Title: NEW Ultrasonic DEF Head Unit
Applies To: All SCR Vehicles

There is a NEW DEF head unit available. This document will guide the user through the differences between the two styles, when to replace a sensor, and what tools/kits are available when diagnostics lead to replacing the DEF head unit.

REPAIR STEP(s)When servicing the ultrasonic DEF head unit and DEF lines, refer to [Exhaust Aftertreatment System with SCR EPA 10 Service Manual](#) for proper repair instructions. Use the proper torque sequence from Figure 6 and Table 4 below.**Figure 6: Ultrasonic DEF head unit torque sequence**

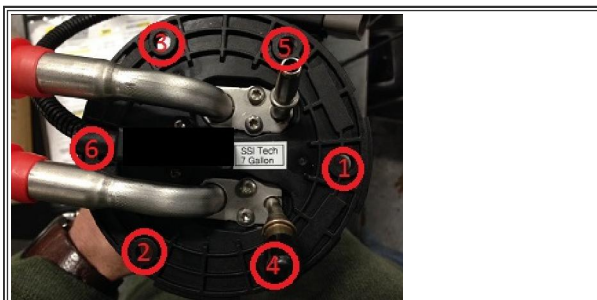
Hide Details		Feedback Information	
		Viewed:	32100
		Helpful:	151
		Not Helpful:	18
Staff ID	Client ID	Comments	Created Date
	DY08955	You received the following feedback From: dy08955 - David Gabrielle Email Address: gabe396@aol.com Job Classification: SE008, Service Technician Dealer: TRUCK KING INTL IDEALEAS Feedback: Please add inch pounds torque spec. to Table 4: Sensor Bolt Torque Sequence	4/30/2019 5:45:18 AM
